Official Transcript of Proceedings
NUCLEAR REGULATORY COMMISSION

Title: Advisory Committee on Reactor Safeguards
Regulatory Policies and Practices

Date: Tuesday, February 2, 2016

REGULATORY POLICIES AND PRACTICES SUBCOMMITTEE

Probabilistic UA includes both the weather variability and the uncertainty in the epistemic input parameters

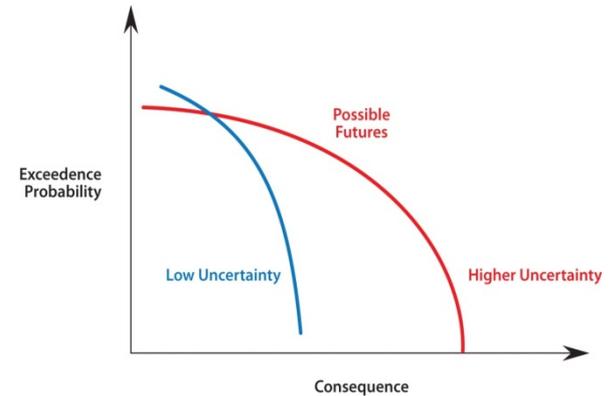
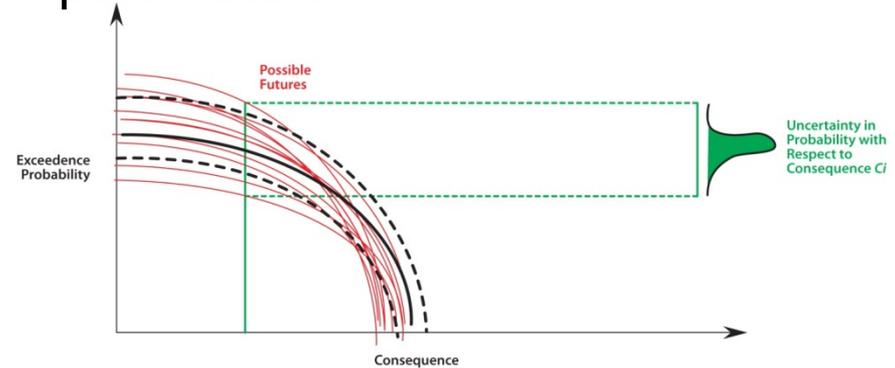
13 So I think eventually in the report we're
14 going to add some figures that look like the family
15 of figures on the right, which will show both the
16 uncertainty due to weather in addition to some
17 example of the spread of individual curves from the
18 epistemic uncertainty.

Figure 3-3 Comparison of NUREG/CR 7110 Vol 2 and UA steam generator nodalizations

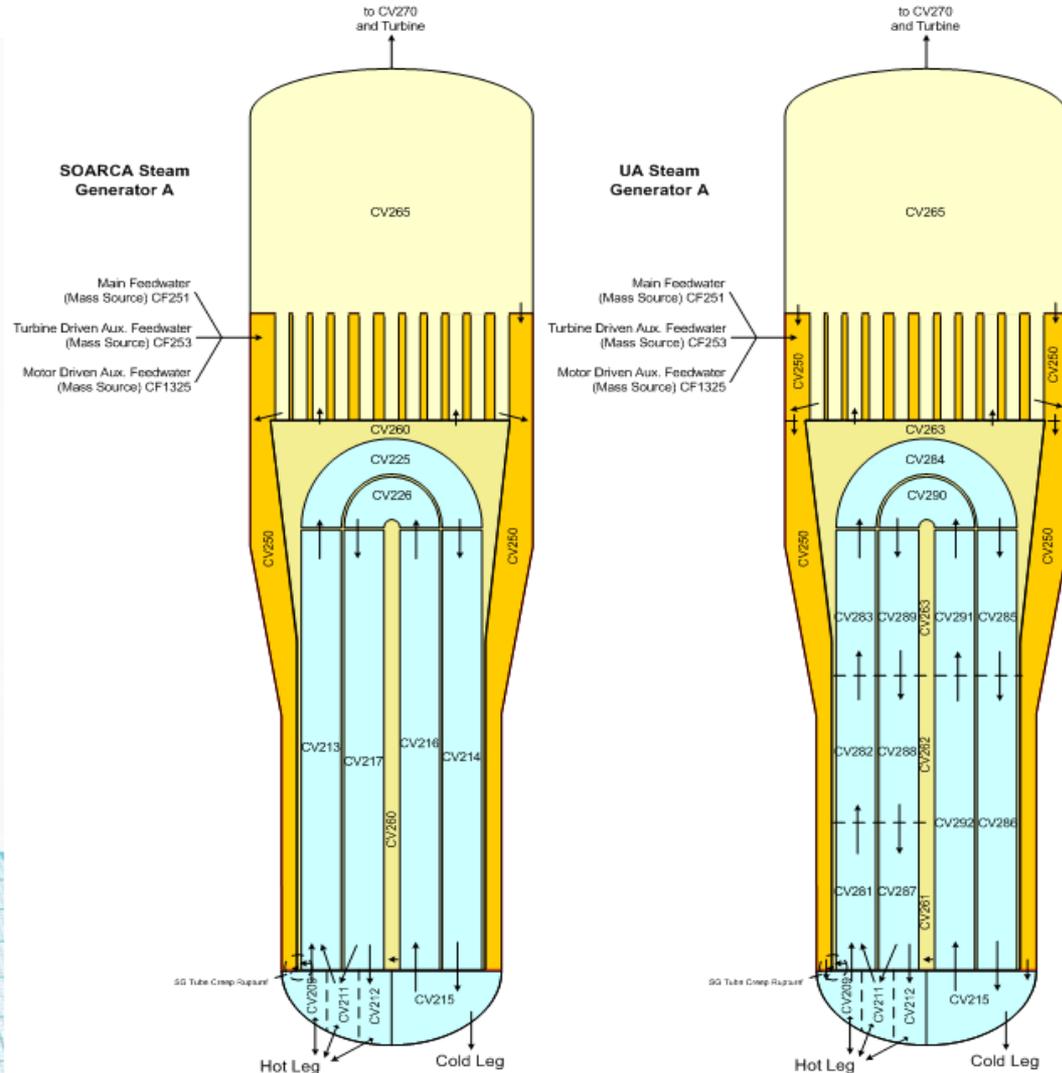
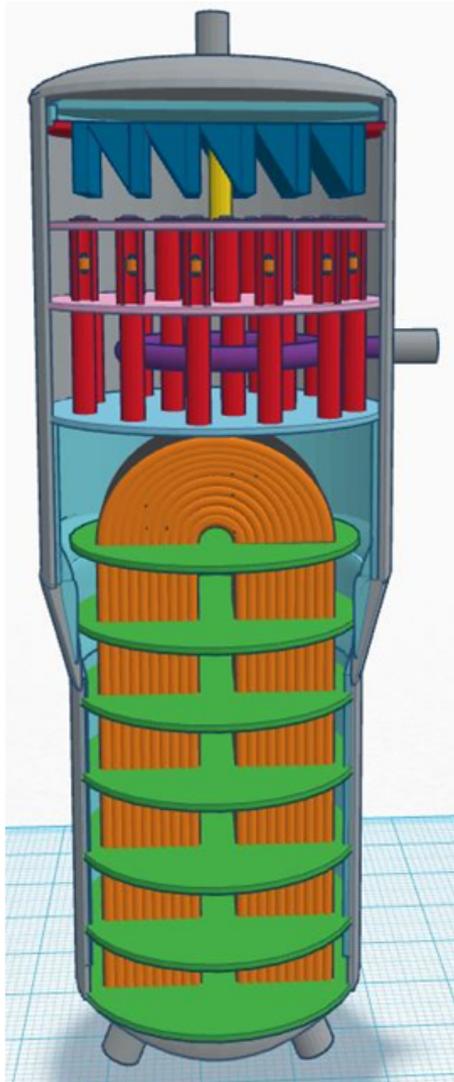
11 MEMBER CORRADINI: So you had - so you
12 had more control volumes in the tube sheet? I'm
13 just trying to look at the difference. I only see
14 more control lines in the tube sheet. Is that
15 correct?

13 But there was a local or a hot tube
14 analysis that really focused close to the tube
15 sheet to make sure that we were able to capture the
16 hottest part of the flume entering the speed
17 generator.
